# PD 3

DEPARTMENT OF PLANNING AND DEVELOPMENT  
CITY OF CHICAGO

**Re: Minor change to PD 3, Subarea E, Connector between Galter and Feinberg Pavilions**

**Sheet Title:** PEDESTRIAN OVERPASS PLAN  
**Applicant:** Northwestern University  
**Address:** 303 E. Superior Street  
**Date:** March 14, 2016

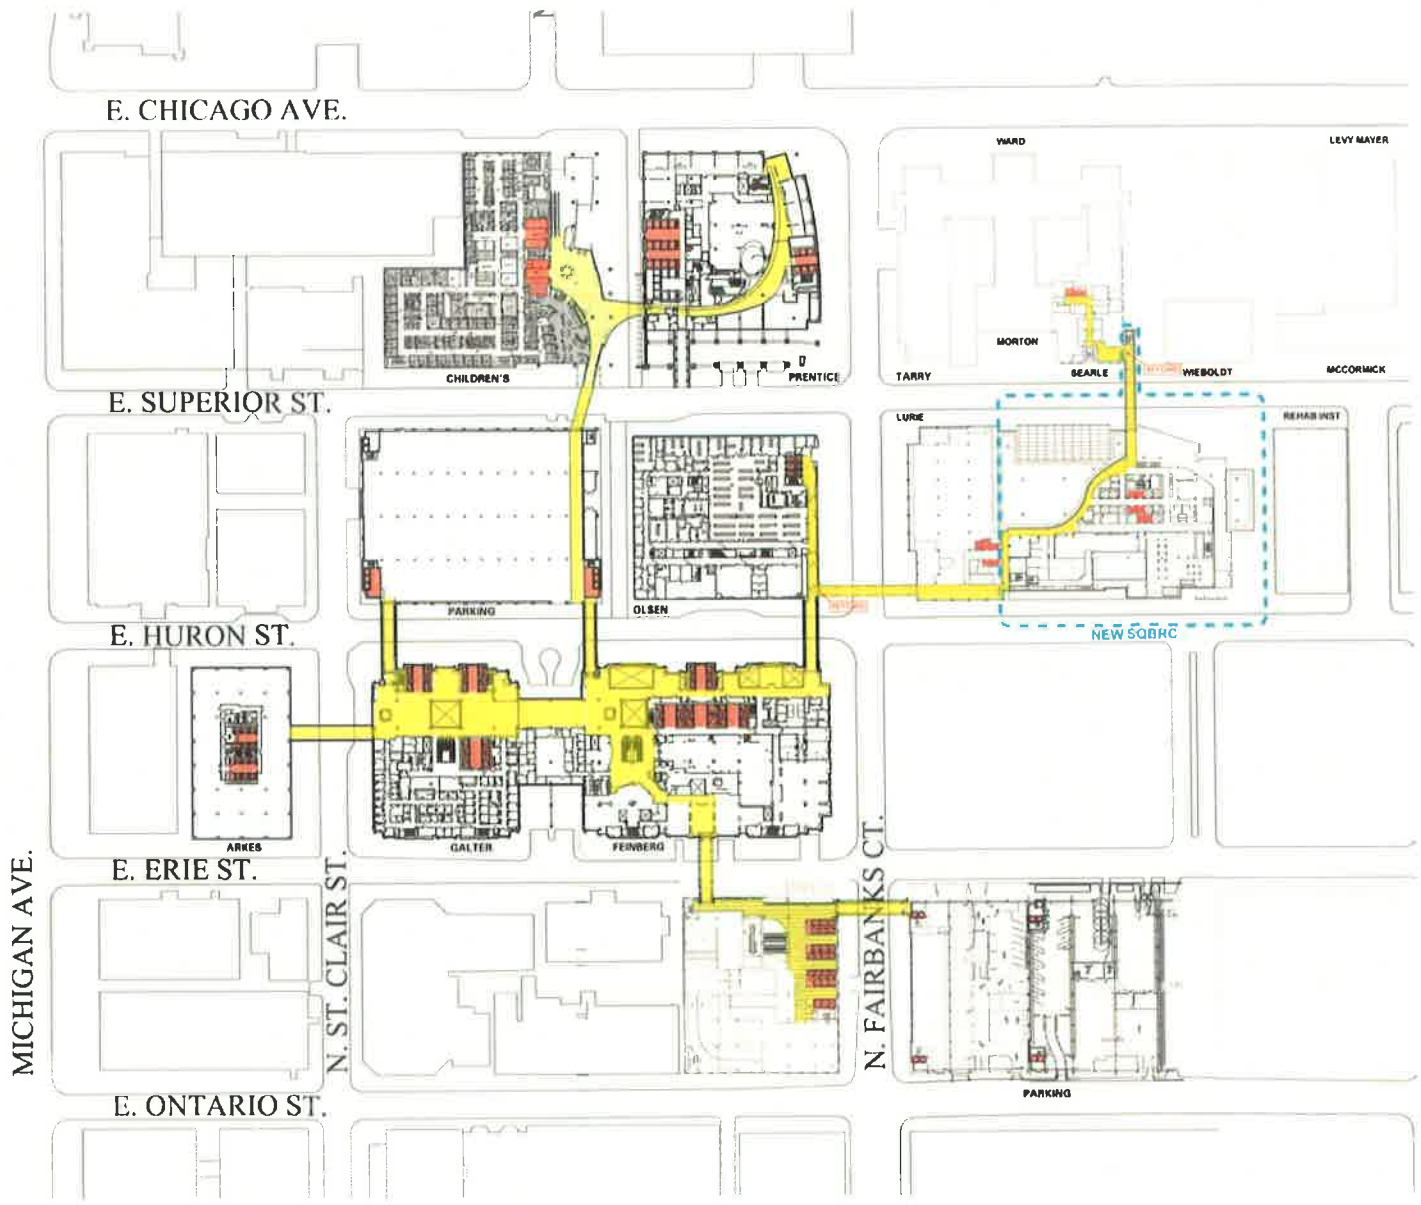
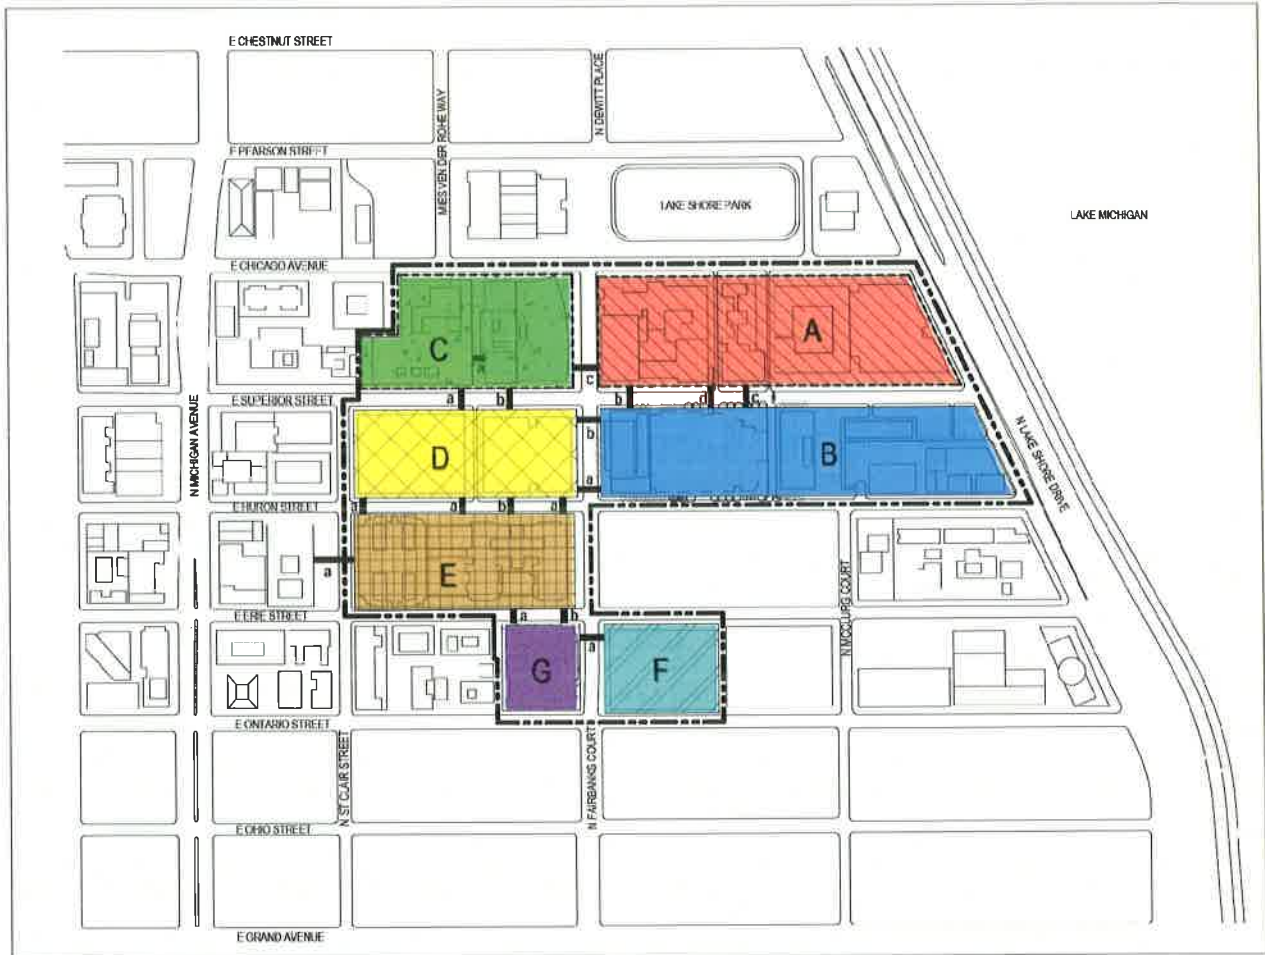
Northwestern University ("NU") is requesting administrative relief to allow for modifications to the proposed pedestrian overpass connection between the second level of the Louis A. Simpson and Kimberly K. Querrey Biomedical Research Center at 303 E. Superior St. and the third level of the Searle Medical Research Building at 320 E. Superior St. The conceptual design and location of the overpass was approved as part of the Biomedical Research Center's site plan approval issued on February 23, 2015. However, the overpass has undergone design refinements since that time primarily to its northern terminus. Adjacent to the Searle Medical Research Building, the width and profile of the overpass has shrunk due to the elimination of an elevator. (Vertical transport between the first and second levels of the overpass will now occur through the use of the interior elevators as opposed to the originally contemplated elevator within the overpass itself). The current design of the overpass also incorporates a bracing structure in the Superior St. sidewalk, on the north side of Superior St.

# GREEN ROOF PLAN

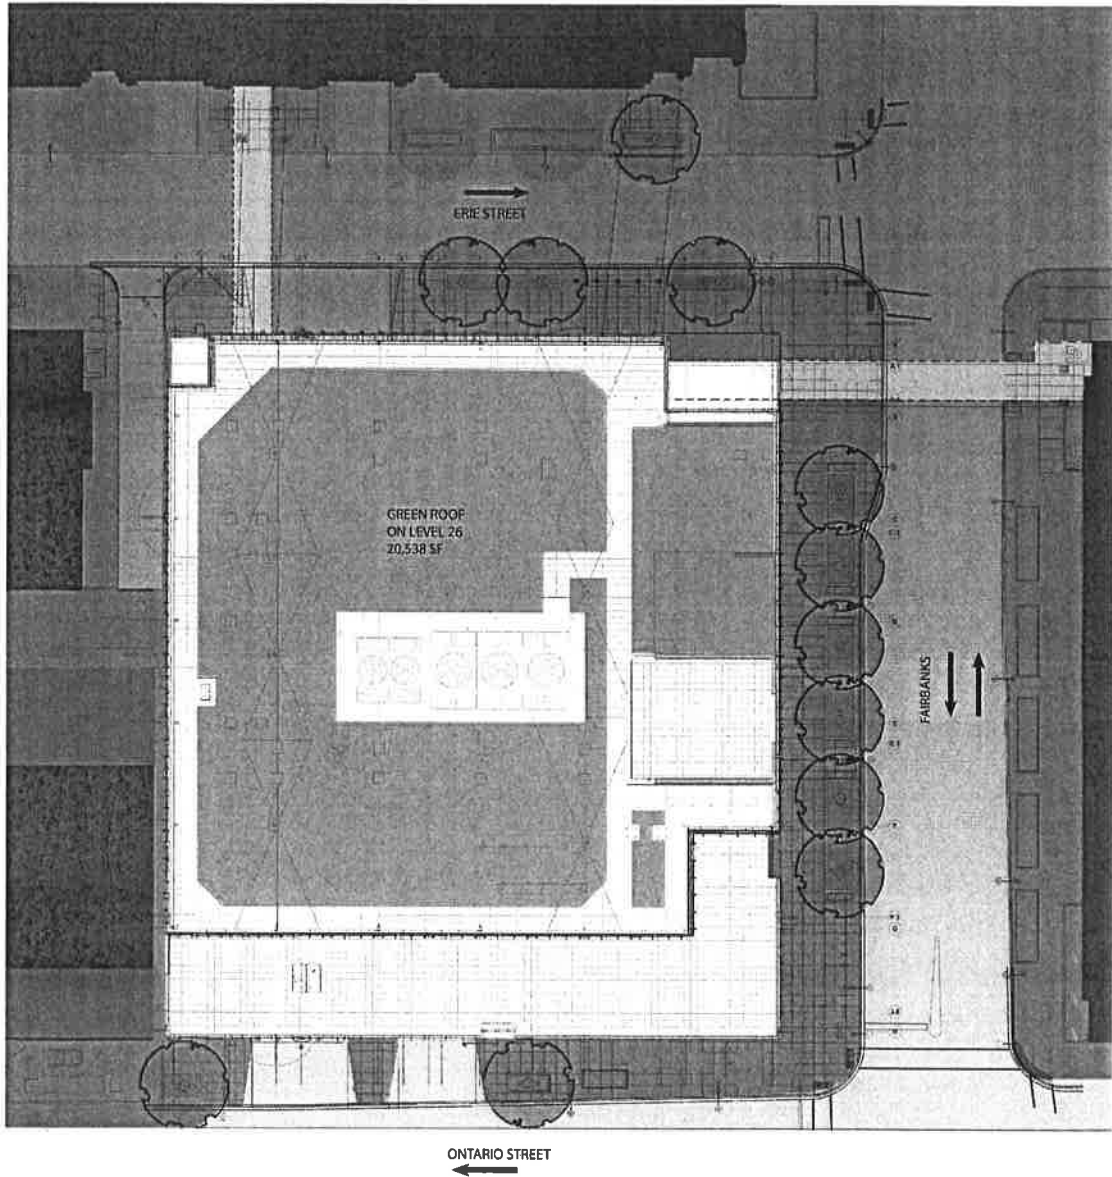
In regards to the first portion of your request, NMH proposes to construct a restaurant with an outdoor terrace on the 18<sup>th</sup> floor and are seeking to enclose approximately 500 square feet of the existing roof terrace. Secondly, due to design and roof surface revisions, the proposed green roofs on several floors were eliminated and relocated. NMH now proposes the elimination of the green roof on floors 18 and 27, and are seeking to provide the required 50% green roof on the 26<sup>th</sup> floor only. The attached, revised 18th Floor Plan, Level 18 Terrace Plan, Green Roof Plan, Partial East and South Elevations, and South and East Building Elevations shall be inserted into the main file.
